AGENDA
REGULAR MEETING OF THE BIRMINGHAM PLANNING BOARD
WEDNESDAY MARCH 27, 2024 – 7:30 PM
151 MARTIN ST., CITY COMMISSION ROOM 205, BIRMINGHAM MI*

SUBJECT: 33816 Woodward – Auto Europe Automotive Group – Final Site Plan & Design Review

RE: Final Site Plan Review Comments
33816 Woodward, Auto Europe

SUBJECT: **33816 Woodward Plan Engineering Plan Review**

Topographic & Boundary Survey

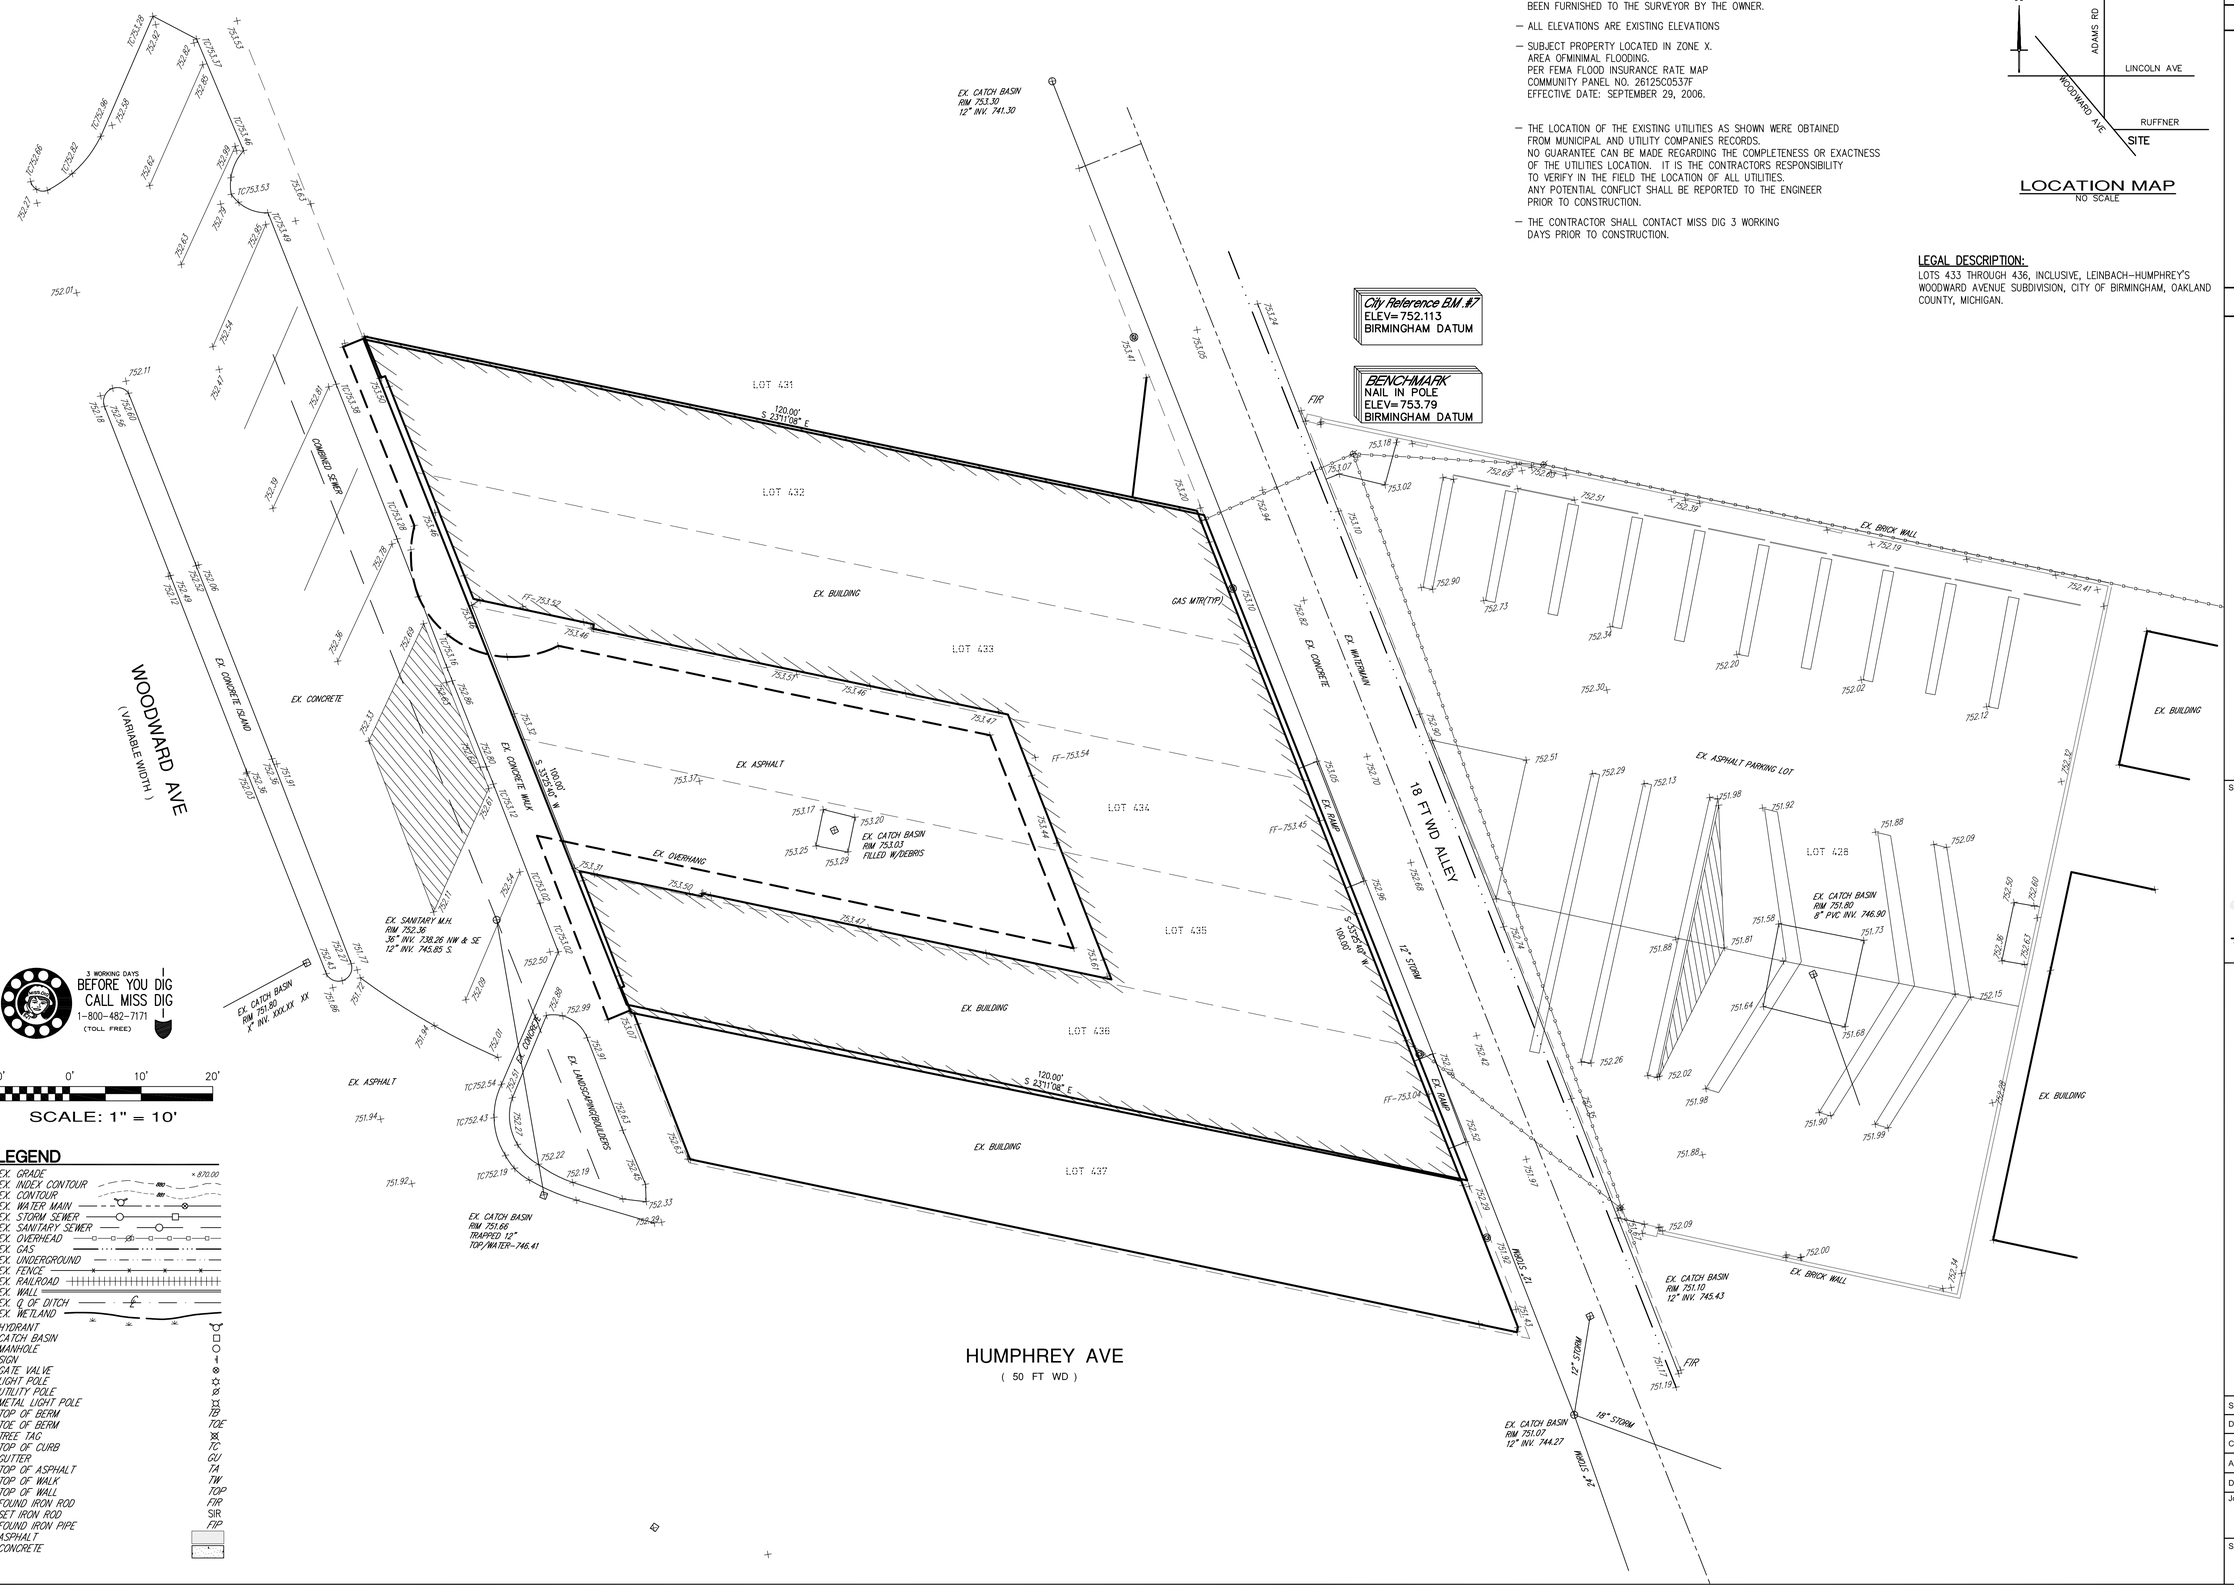
- The Topographic Survey needs to show and label all existing utilities servicing the buildings.
- A utility plan will be required to show how the existing catch basin and sewer will be removed.

PHASE 2 MAIN ENTRANCE - WEST ELEVATION

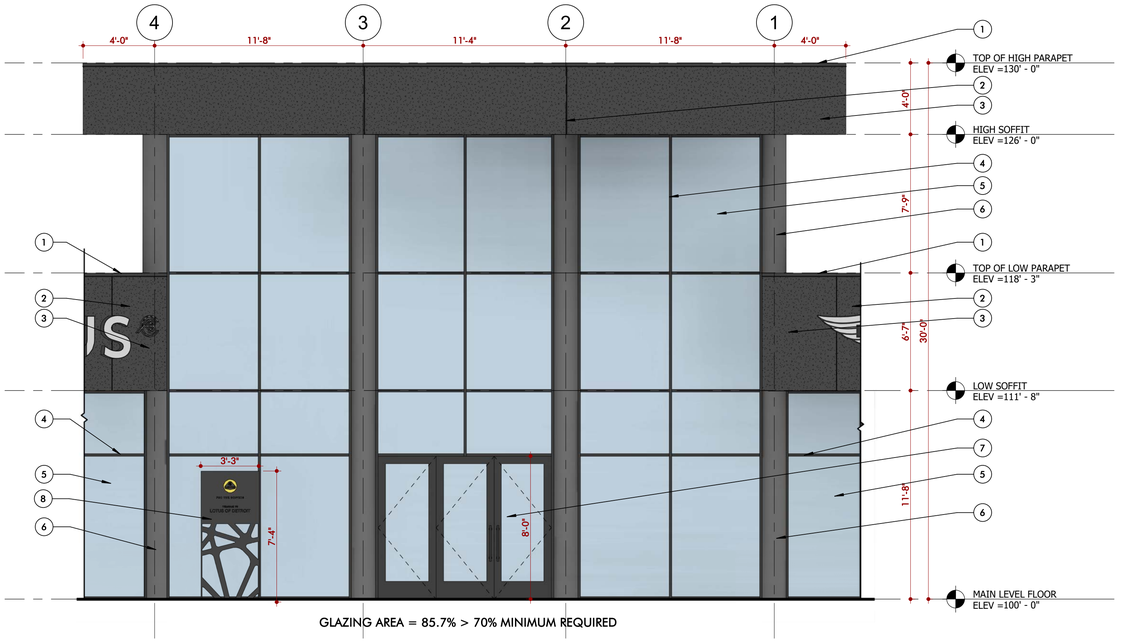
The applicant is proposing to install 3 new recessed light fixtures on the west elevation of the property. The applicant has submitted specification sheets to that display the style of lights. Per Section 4.21 LT-01 C of the Zoning Ordinance, the Planning Division has discretion to not require the submission of a photometric plan if the design does not appear that the proposed lighting will greatly alter the light distribution or illuminance on the site. After review, the Planning Division determined that a photometric plan was not necessary due to the minimal proposed change in light distribution and illumination.

Using the calculations provided, the Planning Division was able to confirm that the proposal exceeds the 70% glazing standards on the storefront (Woodward) side of the building at 77%. The applicant provided spec sheets indicating they would be using a Double Glazed glass that complies with the standards in the Zoning Ordinance with 68% transmittance and 11% reflectance.
